**DAVIS-BESSE
IMPROVED TECHNICAL
SPECIFICATIONS CONVERSION**

**ITS CHAPTER 5.0
ADMINISTRATIVE CONTROLS**

ATTACHMENT 1
ITS 5.1, RESPONSIBILITY

**Current Technical Specification (CTS) Markup
and Discussion of Changes (DOCs)**

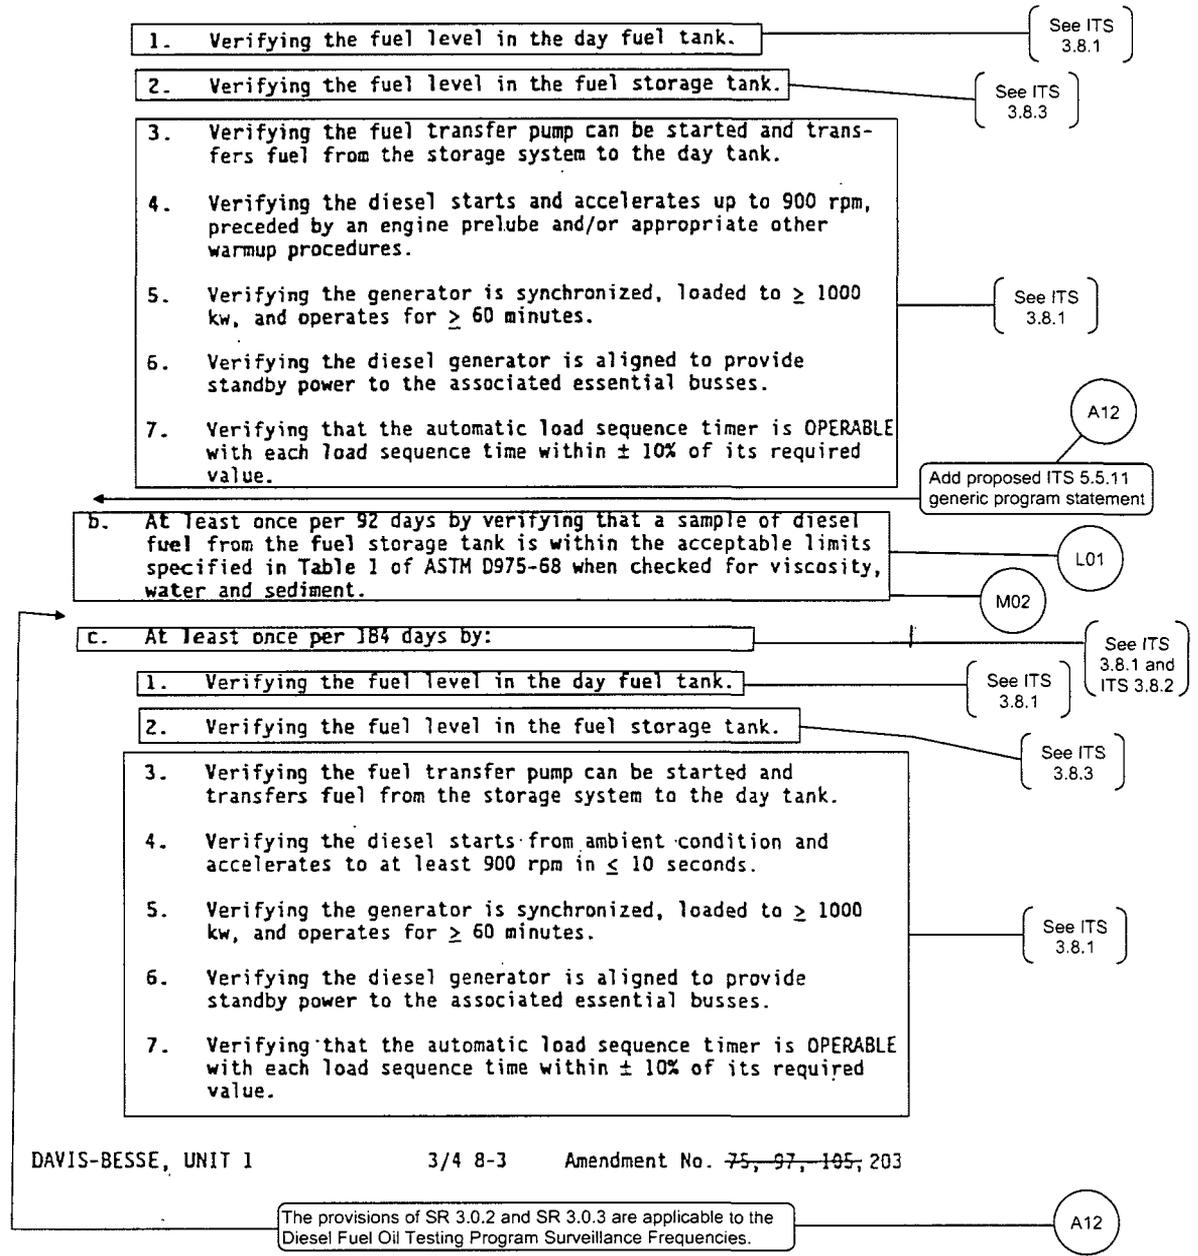
- A11 CTS 4.4.10.b.1 requires reactor vessel internals vent valves to be tested every 24 months. CTS 4.4.10.1.b is modified by footnote *, which states that an exception applies for the interval following March 2003 verification completed during the Thirteenth Refueling Outage. Under this exception, the next performance of the surveillance requirement may be delayed until March 25, 2006. ITS 5.5.4 does not contain this footnote. This changes the CTS by deleting the footnote.

CTS 4.4.10.b footnote * is an exception for the Thirteenth Refueling Outage. Since this refueling outage has been completed and the test has been performed by March 25, 2006 as required by the footnote, there is no need to maintain the footnote. This change is designated as administrative because it does not result in technical changes to the CTS.
